Subject: Municipal Solid Waste – Travis County
Austin Community Landfill – Permit No. MSW 249C
Permit Modification Request – Drainage Improvements

PERMIT PLANS FOR CENTRAL CHANNEL DRAINAGE IMPROVEMENTS

AUSTIN COMMUNITY LANDFILL

MODIFICATION TO
MUNICIPAL SOLID WASTE PERMIT No MSW-249C

CENTRAL CHANNEL DRAINAGE IMPROVEMENTS AUSTIN COMMUNITY LANDFILL AUSTIN, TEXAS
WEST LANDFILL DRAINAGE PLAN

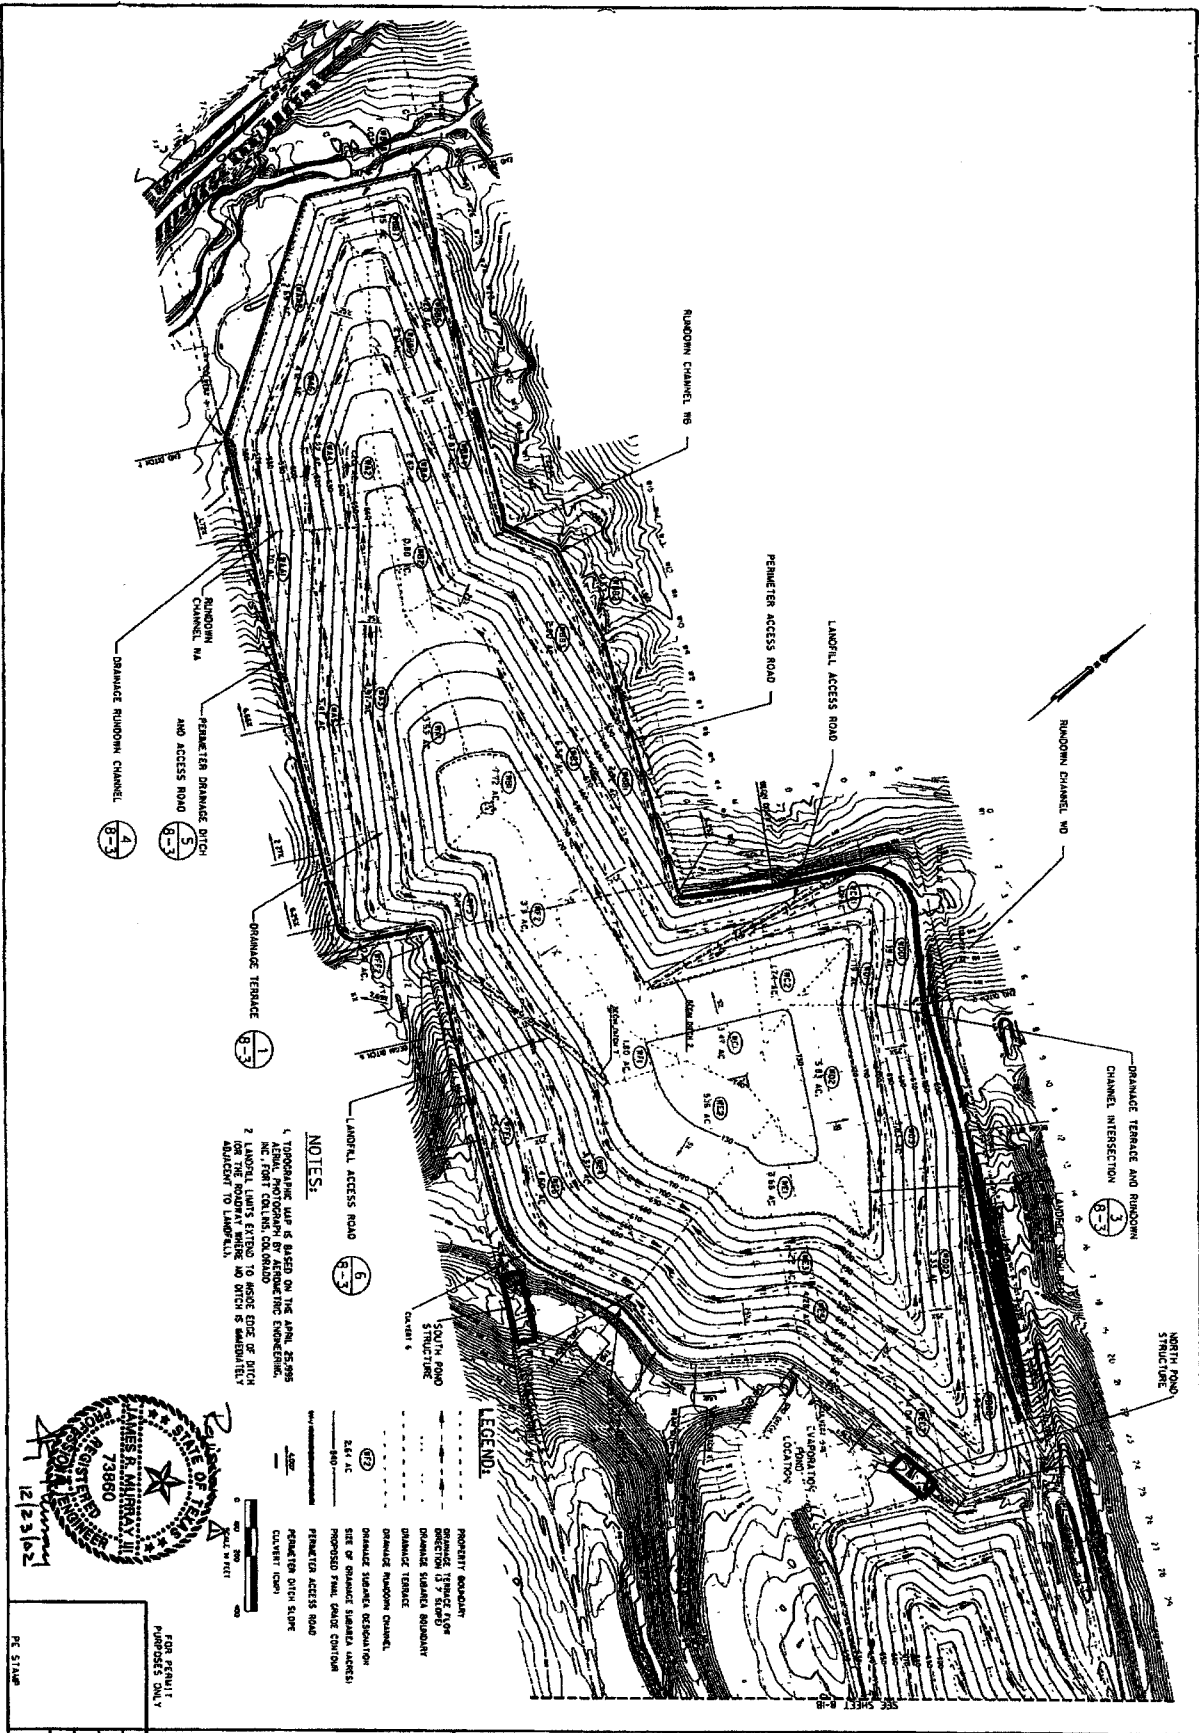
- 1) The addition of culvert 6 on the west hill. This culvert will intercept stormwater flows from the West Landfill Perimeter Ditch 6, Drainage Area WWF1. Currently, these surface water flows continue in Ditch 6 to Culvert 5-6. Culvert 6 will have a 12 inch thick rock riprap discharge pad.

12651 BRIAR FOREST SUITE 205 HEALING TX 73077	I Add North & South Pond Structures and Covers				
DRM: JRM					
DES: JRM					
CHK: BW					
APP: JJK					
TEL: (281) 587-6747 FAX: (281) 293-7876	NO	REVISIONS	ORN	CHK	DATE

SURFACE WATER
 MANAGEMENT DETAILS

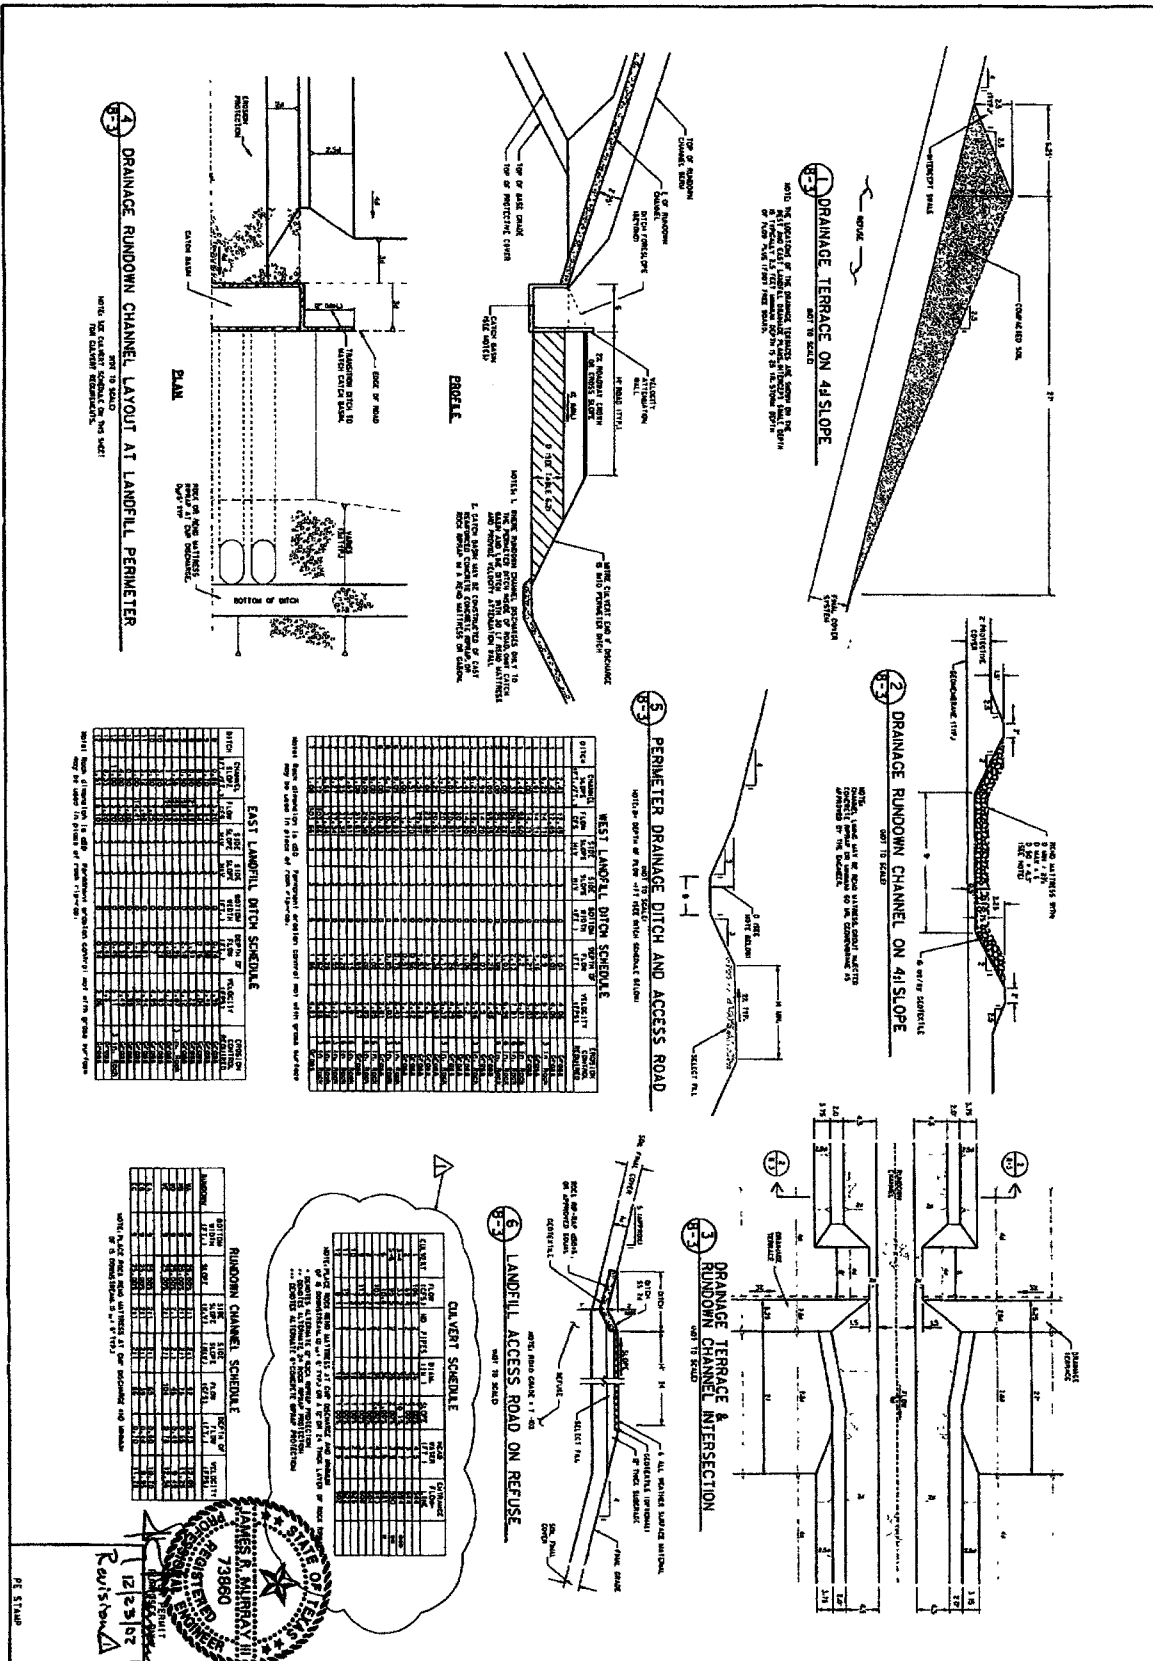
- 2) An alternate to the discharge Reno Mattress of 24-inch thick rock riprap pad has been included for Culvert 5-6. Additionally, revised culvert calculations for Culvert 5-6 representing the actual culvert slopes, lengths and elevations based on current construction survey and design plans have been included.

- 3) Culvert 3-4 has been revised to reflect construction conditions. The culvert slope was increased from 2.00 % to 10.1 %. The Entrance Flow-Line was changed from 588 feet m.s.l. to 594 feet m.s.l. And an alternate to the discharge Reno Mattress of 6-inch thick concrete riprap protection has been included. Revised culvert calculations have been included for Culver 3-4.

NO	REVISIONS	CRN	CHK	DATE
1	REVISED CULVERT SCHEDULE	JRM	JHR	12/02

**CENTRAL CHANNEL SOUTH
 POND STRUCTURE PLAN**

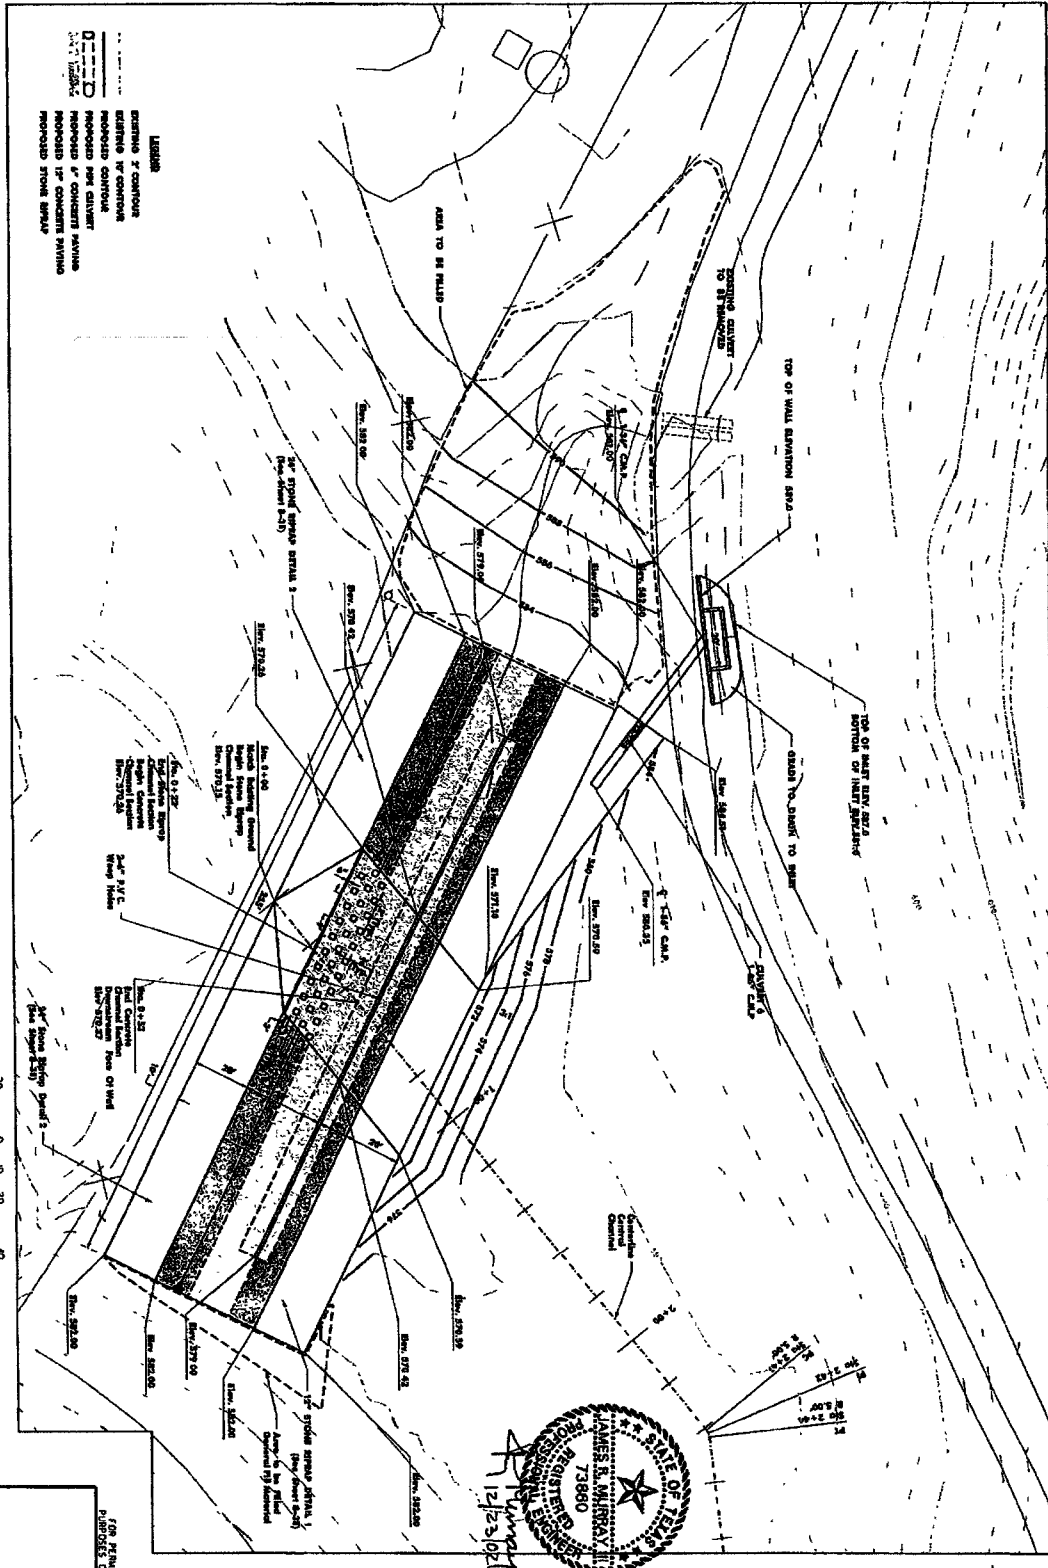
- 5) Two sedimentation ponds have been added to the Central Channel between the East and West Landfills. A wall type weir is proposed for the South Pond Structure. The spillway has been designed to pass the 100-year storm at a depth of 1.78 feet. A concrete lined embankment structure acting at the secondary spillway with three 36-inch corrugated metal pipe culverts and a wall type weir acting as the primary spillway have been proposed for the North Pond Structure. The secondary spillway has been designed to pass the 100-year storm at a depth of 2.41 feet. Both structures will allow for storage behind the wall with dewatering provided from two six-inch pipes located at the base of the walls. A combination of concrete stilling blocks, concrete riprap, and 24 inch thick stone riprap have been included to protect the downstream receiving channel from erosion at both pond structures.

Section	Title	Description
Appendix 2.3	Post-Development Drainage Calculations	Addition of calculations for southern pond structure, northern pond structure, CH2 alternate channel configuration, culvert 6, stone riprap. Revision of the calculations for culverts 3-4 and 5-6.
Attachment 8, Sheet 9 of 10 (figure)	Developed Surface Water Plan	Addition of a CH2 alternate channel configuration included only as a supplement to the above referenced Appendix 2.3. No change was made to this Attachment 8, Sheet 9 of 10.
Attachment 8-1A (figure)	West Landfill Drainage Plan	Addition of southern pond structure, northern pond structure, and culvert 6.
Attachment 8-3 (figure)	Surface Water Management Details	Addition of culvert 6, stone and concrete riprap outlet protection and revision of culverts 3-4 and 5-6.
Addition of Attachment 8-3A (figure)	Central Channel South Pond Structure Plan	Addition of a Central Channel South Pond Structure Plan.

CENTRAL CHANNEL SOUTH POND STRUCTURE PROFILE
(NOT TO SCALE)

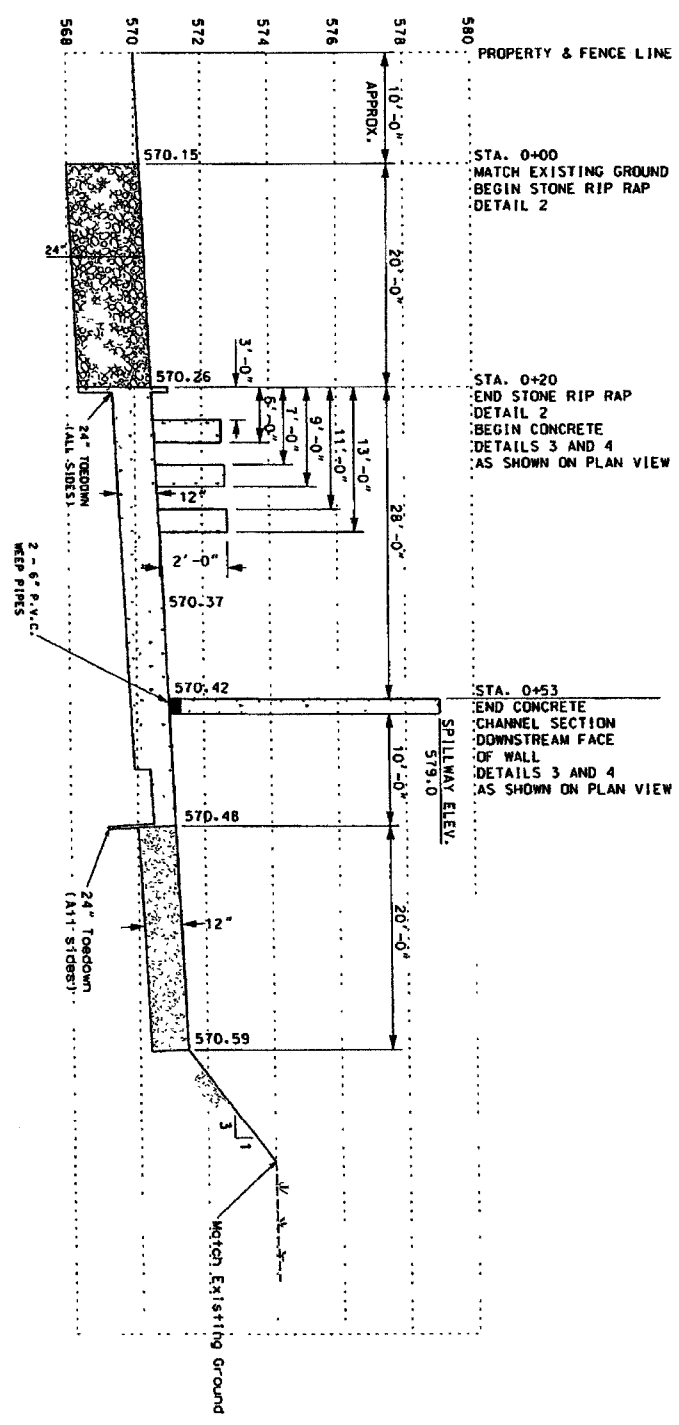
Addition of Attachment 8-3B (figure)	Central Channel South Pond Structure Profile	Addition of a Central Channel South Pond Structure Profile.
Addition of Attachment 8-3C (figure)	Central Channel North Pond Structure Plan	Addition of a Central Channel North Pond Structure Plan.

CENTRAL CHANNEL NORTH POND STRUCTURE PROFILE
(NOT TO SCALE)

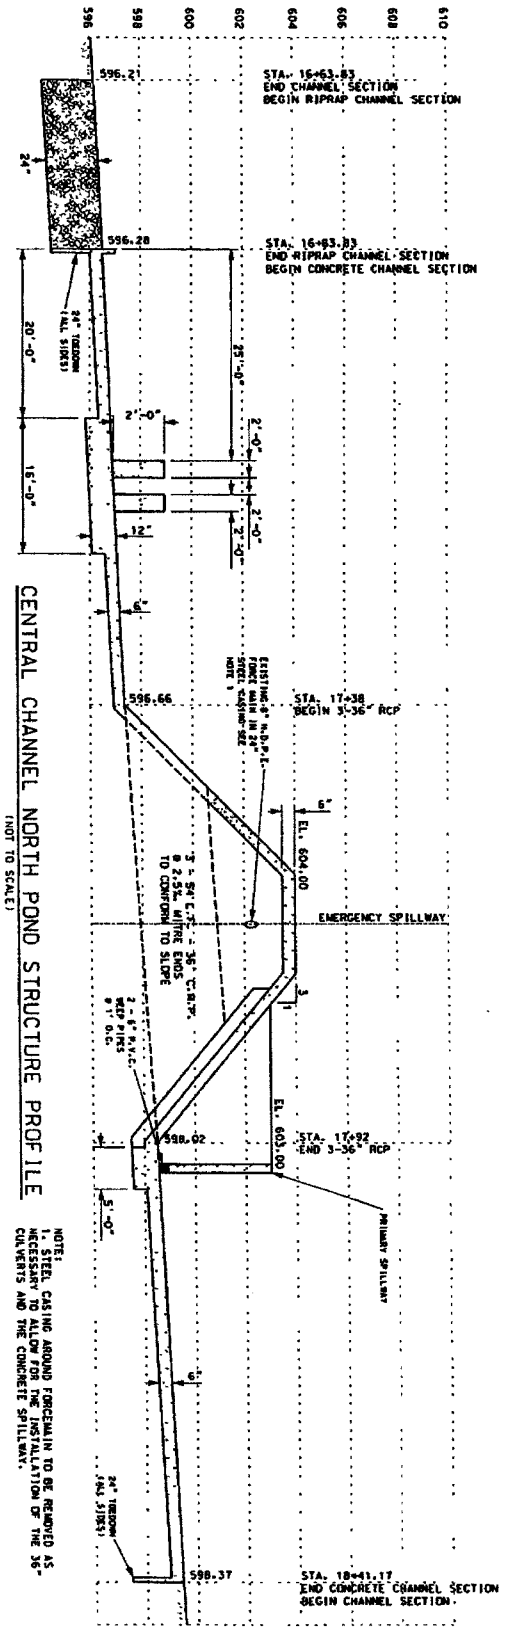
Section	Title	Description
Addition of Attachment 8-3D (figure)	Central Channel North Pond Structure Profile	Addition of a Central Channel North Pond Structure Profile.
Addition of Attachment 8-3E (figure)	Surface Water Management Details	Addition of 12 inch and 24 inch Stone Rip-rap Details.
Addition of Attachment 8-3F (figure)	Surface Water Management Details	Addition of 6 inch and 12 inch Concrete Paving Details.

CH2 Alternate Channel Section

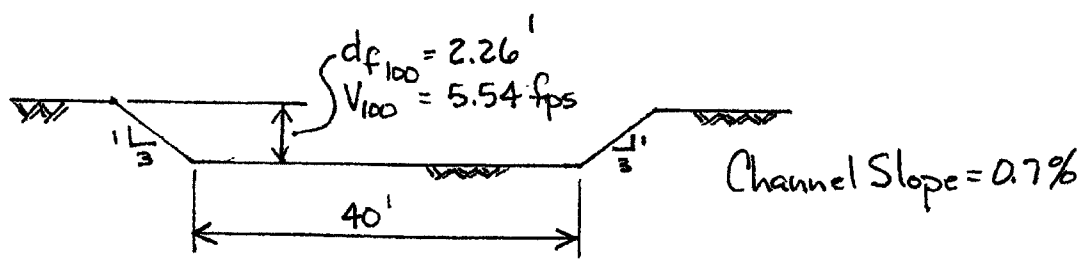
- 4) An alternate to Channel CH2 has been included. Currently, Channel CH2 is permitted as a 50-foot wide vegetated earthen trapezoidal channel with 3:1 side slopes and a channel slope of 1.30 %. An alternate channel configuration of 40 foot wide vegetated earthen trapezoidal channel with 3:1 side slopes and a channel slope of 0.70 % has been included. Channel calculations have been included.

CH 2 - Alternate Channel Configuration
